DEADLINE 3 RESPONSE – MR NEIL ALSTON (the 'respondent' as represented by his agents) RESPONSE TO HIGHWAYS ENGLAND COMMENTS ON RELEVANT REPRESENTATIONS

RR-074.1

ROUTE 1

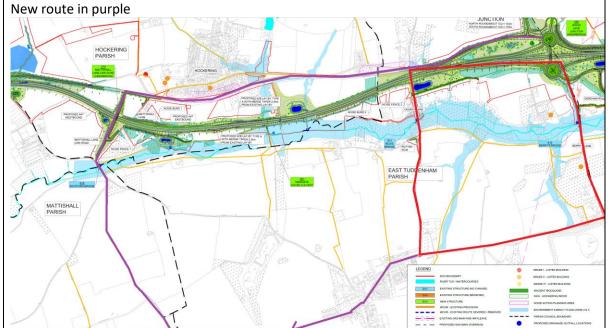
Route 1 - west through East Tuddenham to the Mattishall Lane link road and then back east along the old A47, taking 6km and involving taking machinery through East Tuddenham.

Route 2 — east to the Honingham Church roundabout, double back along the old A47 to the Wood Lane Grade Separated Junction (GSJ), to the north side of Wood Lane. Taking an extra 3km of journey compared to using Berry Hall Lane.

The proposals sever the Property, significantly impact the efficacy of running a farming business on the Property, put a significant number of agricultural vehicles on the highways network rather than keeping them localised, and pushes traffic through East Tuddenham.
